**SAFETY OF HEPA FILTER UNITS IN HANFORD
B-PLANT EXHAUST VENTILATION SYSTEM**

This issue paper was prepared for the Defense Nuclear Facilities Safety Board by the following staff members:

April 15, 1996

Figure 1
4

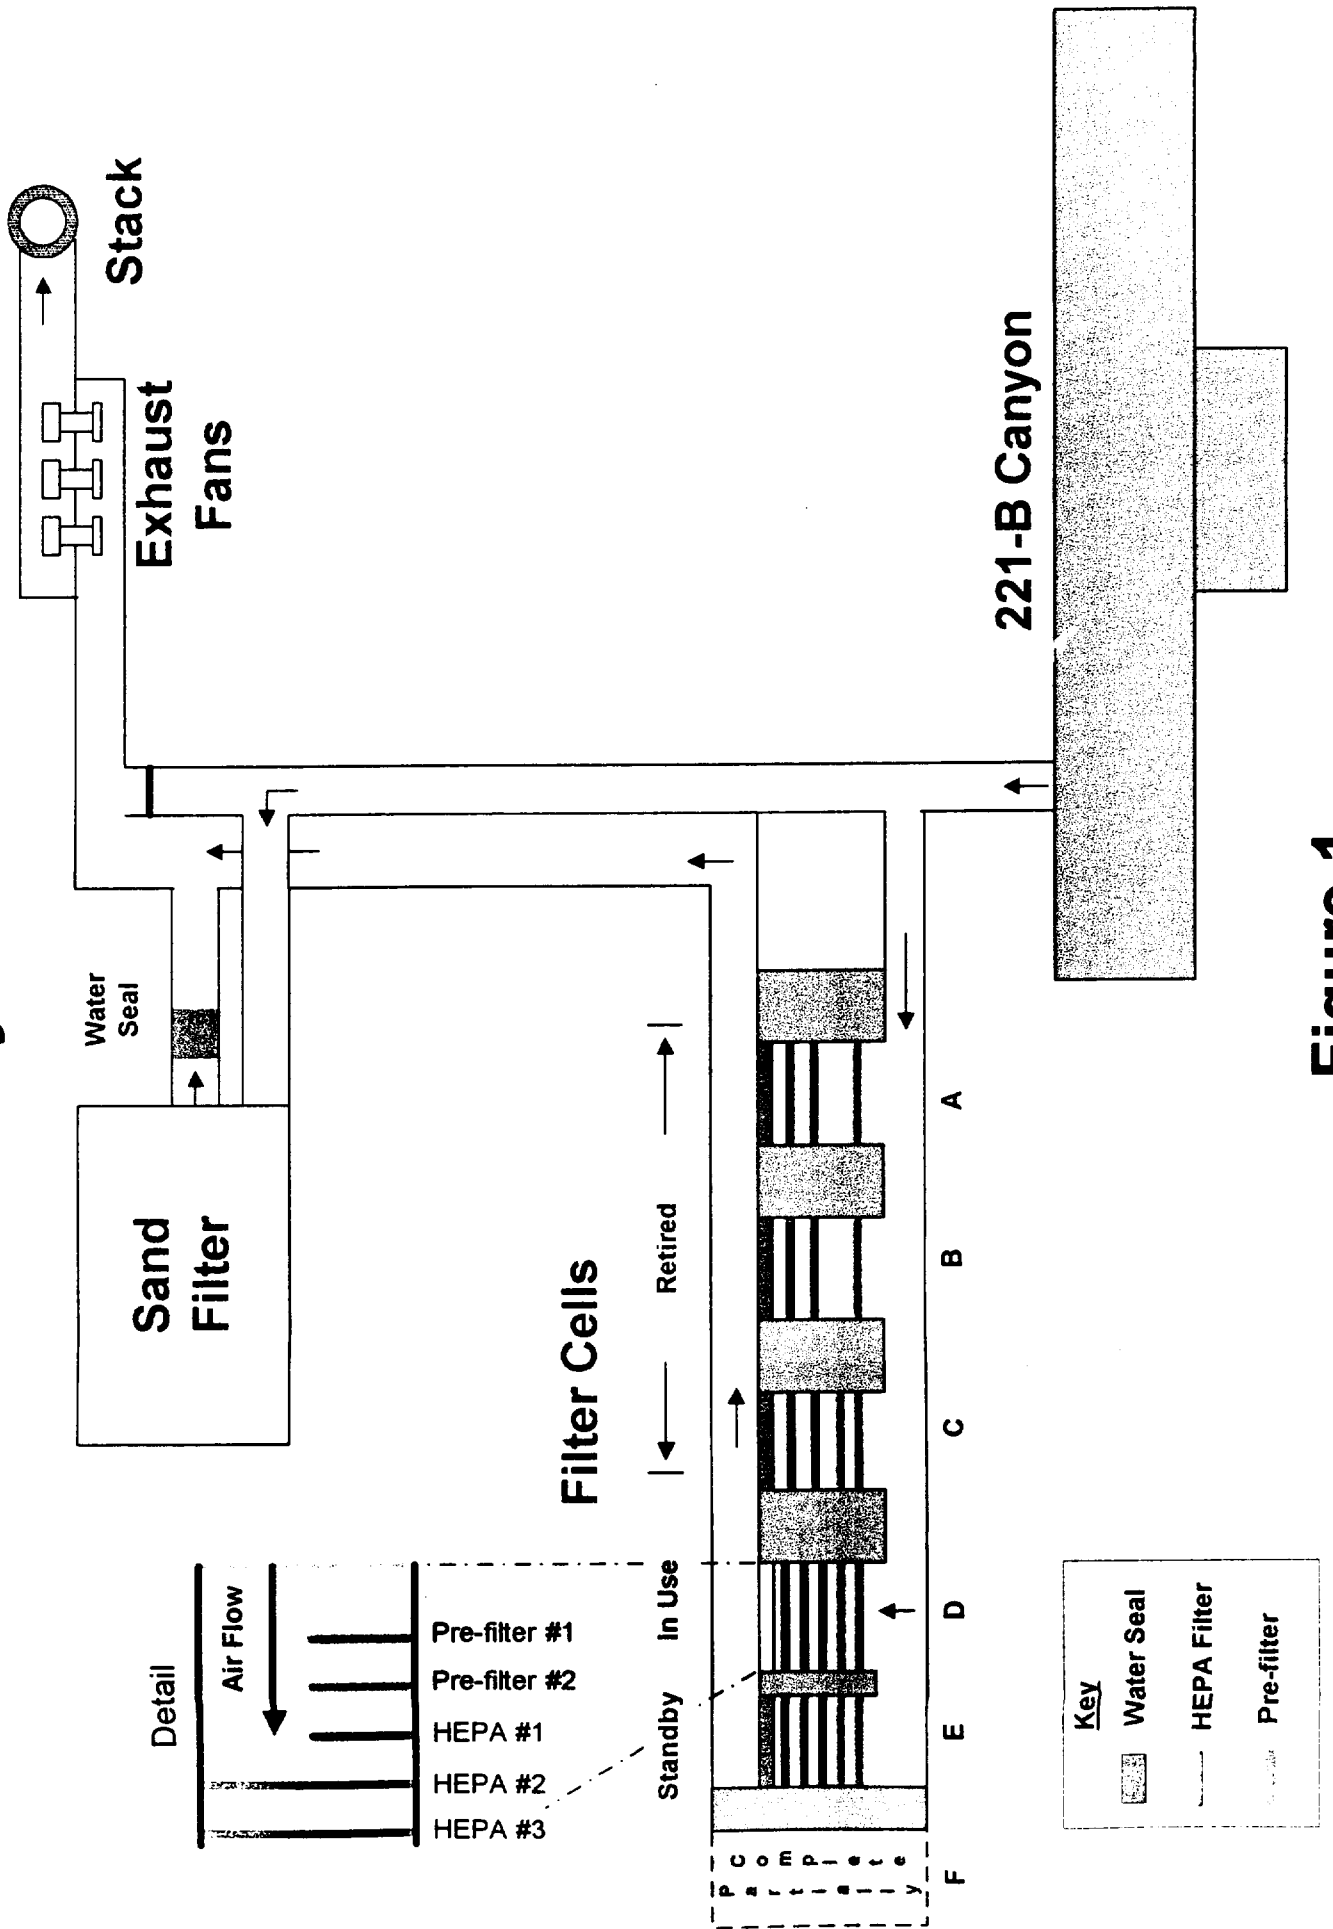
The current differential pressure drop across the last HEPA filter bank (Filter #3) is approximately 0.42 inch of water column, whereas the differential pressure across the other operating HEPA filter bank (Filter #2) is approximately 0.35 inch of water column. The detail on Figure 1 depicts the various filter banks. Based on the data, there is either a problem with the instrumentation or the first HEPA filter bank (Filter #2) is operating at less than acceptable performance. Based on operating experience, one would expect the downstream HEPA filter bank (Filter #3) to have a lower differential pressure than the upstream HEPA filter bank (Filter #2) because of the increased loading on the upstream HEPA filters. Additionally, the differential pressure across Filter #2 is less than that expected for a new HEPA filter, while the differential pressure across Filter #3 is greater than that expected for a new HEPA filter. This could mean that Filter #3 is slightly loaded and that Filter #2 has experienced localized breakthrough.

WHC speculates that the flow path around the bypassed filters (pre-filters and HEPA Filter #1) creates a flow pattern such that there is a nonuniform flow (i.e., nonuniform air velocities upstream of HEPA Filter #2) that could influence the static pressures measured by the instrumentation. However, it appears more likely that the lower differential pressure across Filter #2 is due to localized breakthrough of the filter that would result in a lower flow resistance and a lower differential pressure. The breakthrough is most likely localized based on the Filter #2 differential pressure measurements and the results of the filter

Figure 2

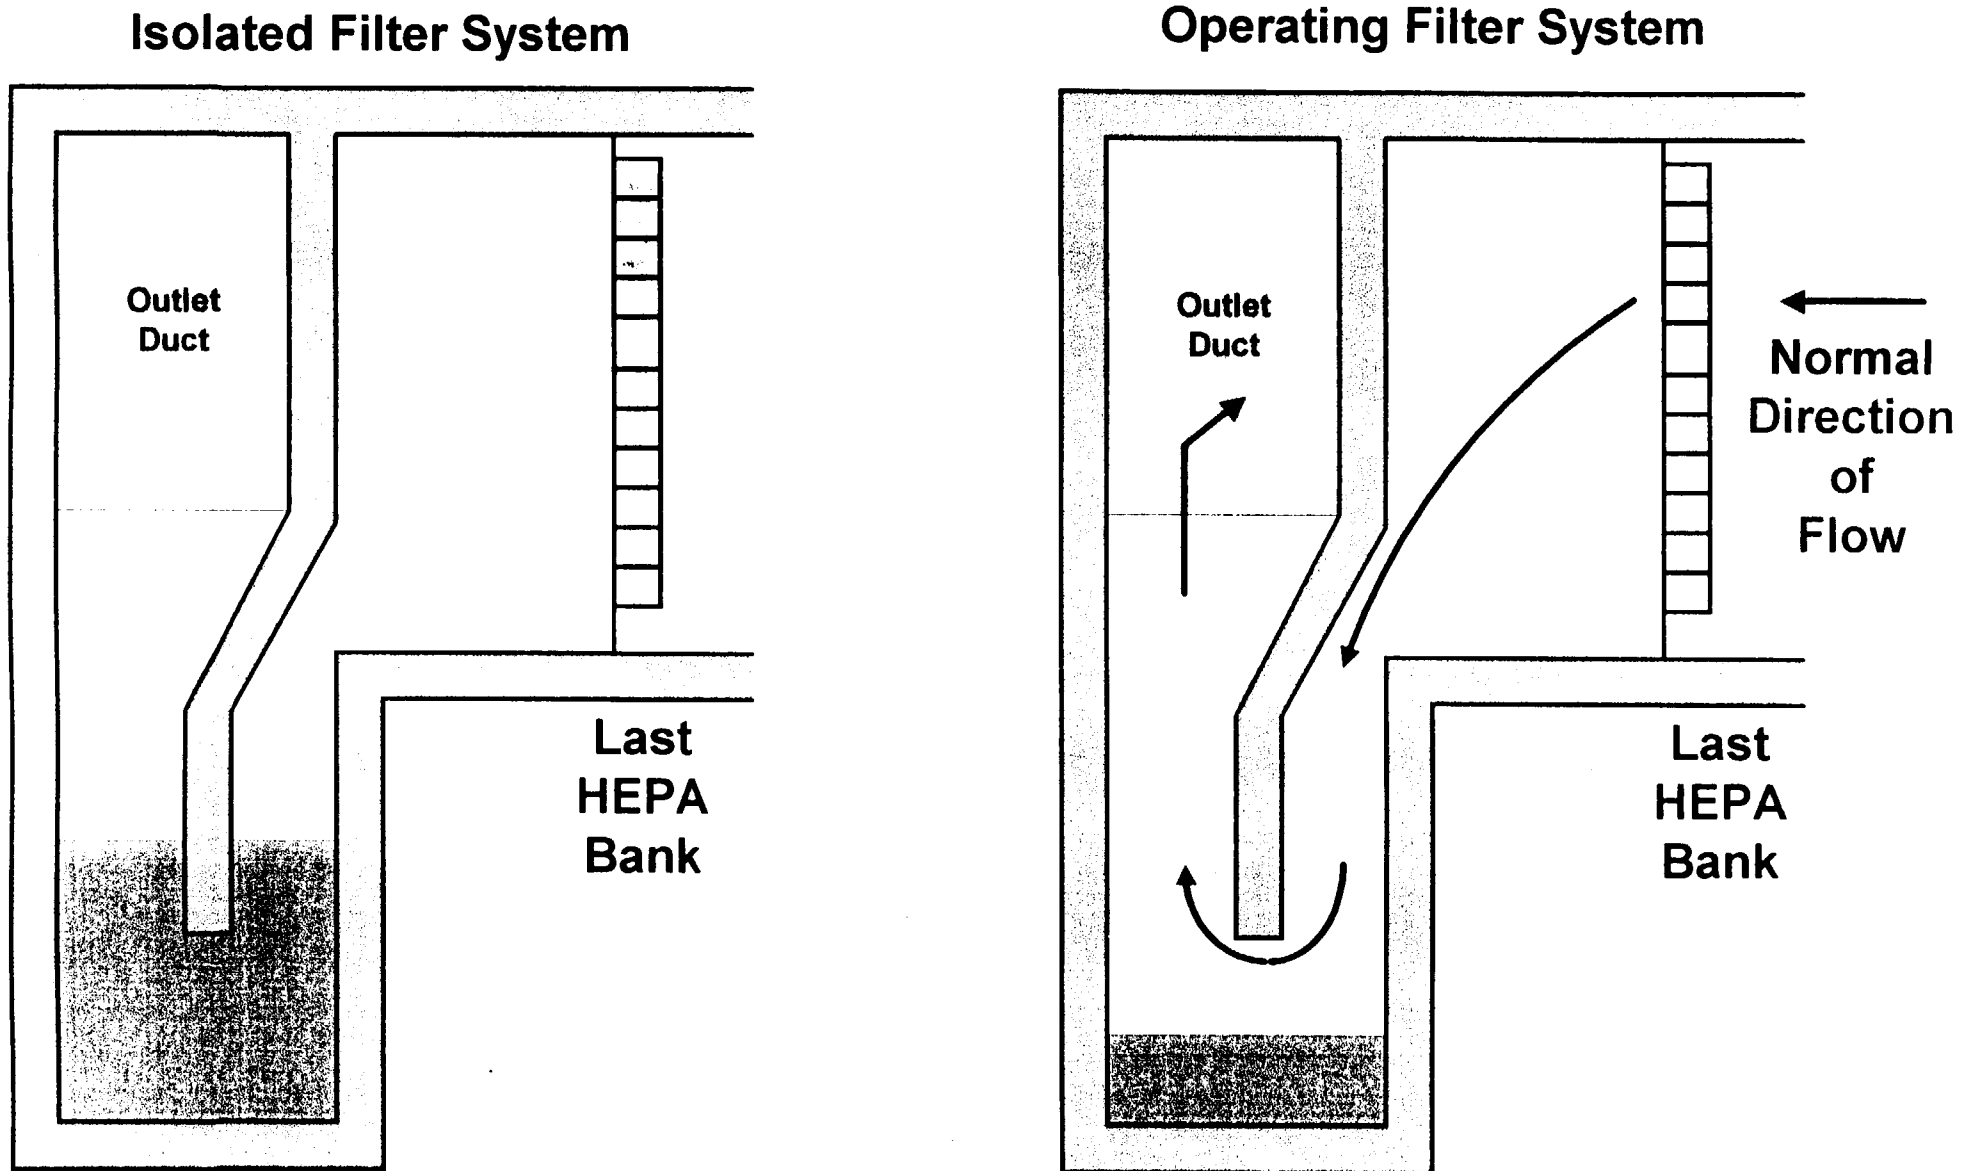
Although water seals may be appropriate for remotely operating inaccessible filter units, they do not provide a reliable long-term isolation function for retired or deactivated filter units. The water seals were not designed to meet single failure criteria and could be subject to inadvertent rapid draining (e.g., steam jetting) or gradual draining (e.g., evaporation, leaks). The water seals are also subject to overfilling that can flood the filter cells and wet the HEPA filters, which would further degrade the integrity of the filters. The flooding can also provide another mechanism for transport of radionuclides from the HEPA filters to the environment. As noted in Appendix A, retired filter units have been inadvertently flooded on two occasions.^{22,23,24}

In the past, WHC had considered various alternative schemes for isolating HEPA filters, including grouting and use of a nonvolatile liquid or foam material. All of these alternatives were rejected, and there are no near-term plans to replace the water seals. Leaving the outlet water seals of the retired filter units in their present configuration for several more years does not appear to be prudent. It appears that additional effort is warranted to identify an alternative that would provide enhanced reliability and not adversely impact future remediation of the filters. For example, the suitability of using a fine sand should be analyzed. The sand could be pneumatically and remotely substituted for the water, would be temporary, and would not be susceptible to inadvertent jetting.
